**Product Discontinuation  
Notices**

No. 2019059CE

**Discontinuation Notice of FA Wireless LAN Unit Model WE70 series****Product Discontinuation**

[ Dimensions ]

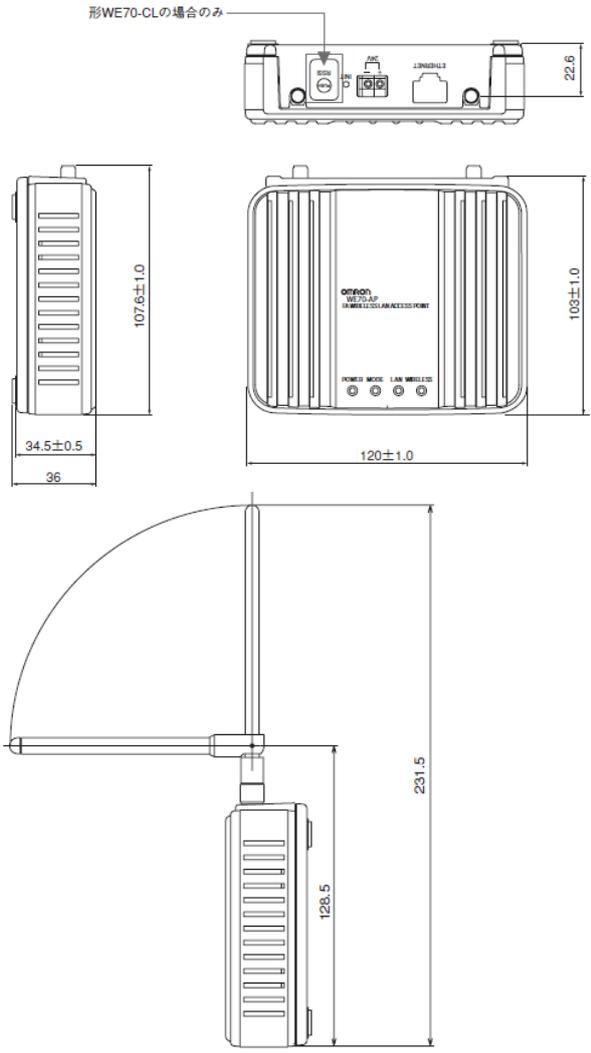
Product discontinuation Model WE70 series	Recommendable replacement Model AWK series made by MOXA Inc.
<p><b>WE70 series</b></p>  <p>形WE70-CLの場合のみ</p> <p>107.6±1.0</p> <p>34.5±0.5</p> <p>36</p> <p>22.6</p> <p>103±1.0</p> <p>120±1.0</p> <p>231.5</p> <p>128.5</p> <p>(単位：mm)</p>	<p><b>AWK-3131A(KS)</b> 52.7 × 135 × 105 mm</p> <p>52.05 [2.049]</p> <p>105.00 [4.134]</p> <p>135.00 [5.315]</p> <p><b>AWK-1131A(KS)</b> 58 × 115 × 70 mm</p> <p>57.30</p> <p>115.00</p> <p>121.90</p> <p>70.00</p> <p>80.00</p>
